**LARAMIE COUNTY CLERK
BOARD OF COUNTY COMMISSIONERS
AGENDA ITEM PROCESSING FORM**

Consideration of a Subdivision Permit and Plat for Meadowlark Ridge Estates, a portion of the East ½ of Section 31, T. 15 N., R. 67 W., of the 6th P.M. , Laramie County, Wyoming.

TITLE: Review and action of a Subdivision Permit and Plat for Meadowlark Ridge Estates, a portion of the East ½ of Section 31, T. 15 N., R. 67 W., of the 6th P.M. , Laramie County, Wyoming, located adjacent to and north of Horse Creek Road, east of County Road 118A.

Subdivision Permit and Plat PZ-14-00194

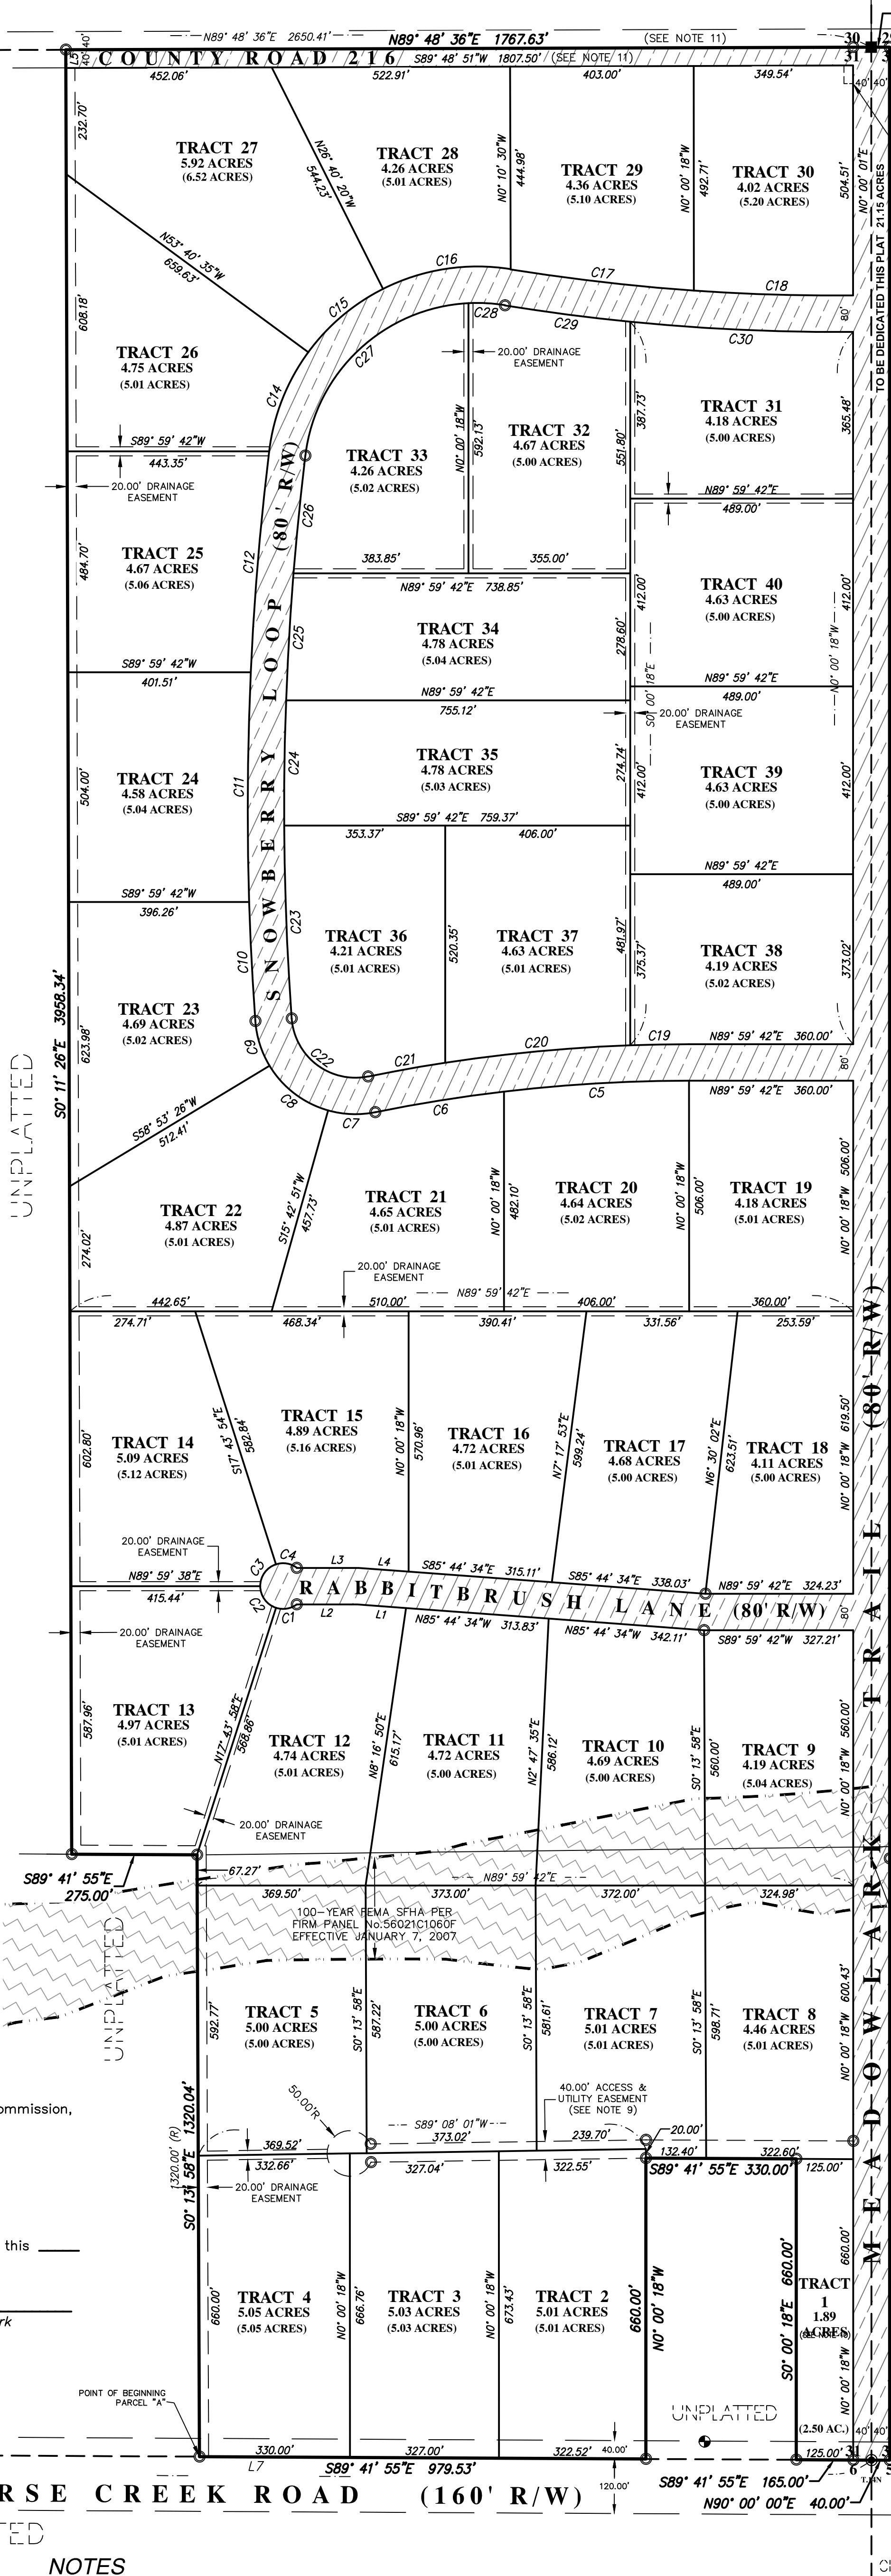
In the 160 acres proposed for development, As shown bordered in red on the Plat there are 32 Tracts (#s 9 thru 40) after removing the 19.5 acres for road access it would leave 140.5 acres divided by 32 = 4.39 acres (average) The county at present time has a min. requirement of 5 acres, and the State Engineers Office recommends 8.5 acres,

Also to note, Tracts # 5 thru 8 are only showing a 40 ft. right of way and access to property, why not the standard 80 ft road? Why is it not on the Plat at this time to be built? (no access)

Tracts # 2,3,6,7,8. would represent 24.51 acres also below the 5 acres (without the additional reduction due to no road access shown on the Plat)

Tract 3 & 4 have 3 well permits shown on the State Register now and would need to be amended with the State Engineers Office Ground Water Division, because of the acreage size reduction for those wells.

There also is a cemetery in the Tract #1 which is designated as 1.89 acres of open space, what is the plan for it? (Does it have a well?)
